# 78 Greencroft Gardens, NW6 3JQ, 2014/2979/P

Delegated Report		Analysis sheet		Expiry Date:	05/06/2014		
(Members Briefing)			N/A		Consultation Expiry Date:	21/04/2014	
Office	r			Application Nu	mber(s)		
Niall SI	heehan			2014/2979/P			
Applic	ation Add	ress		Drawing Number	ers		
78 Greencroft Gardens London NW6 3JQ			Refer to Decisio	n Notice			
PO 3/4	Area Tean	n Signature	C&UD	Authorised Offi	cer Signature		
Proposal(s)							
Enlargement of existing basement and creation of lightwells to the front elevation of flats.				flats.			
Recommendati on(s):		Grant cond	nditional permission subject to a S106 agreement.				
Application Type:		Full Planning Application

**1.1** Enlargement of existing basement and creation of lightwells to the front elevation of flats.

Image: 3D View of 78 Greencroft Gardens, 5<sup>th</sup> building in from right hand side, gravel area to front garden.

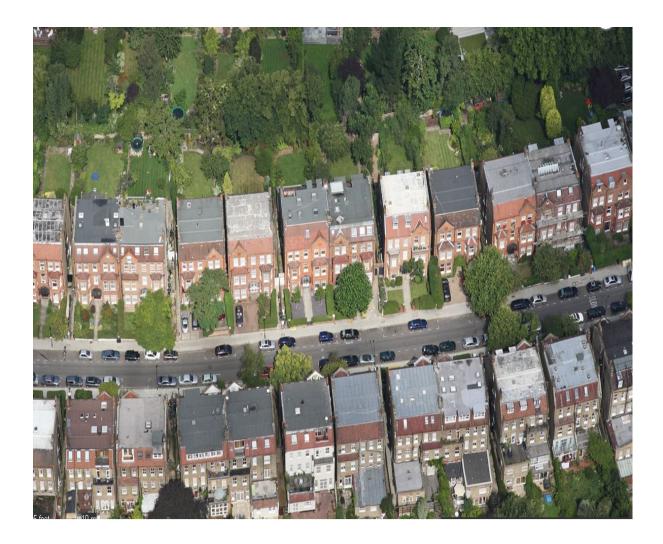
Middle & Bottom: Image of where lightwells would be positioned, either side of the entrance footpath

**3.2** The extension to the front elevation consists of two lightwells of matching depths either side of the front entrance are considered to be in keeping with character or appearance of the host property, those surrounding or the wider Conservation Area .Furthermore by virtue of the provision of a grille (instead of a front wall or railings) this will ensure the development will not be explicitly visible from the public realm when complete. In any instance the basement level is considered to reasonably accord with that of the ground floor directly above, and, the provision of a grille lightwell is considered appropriate in this instance.
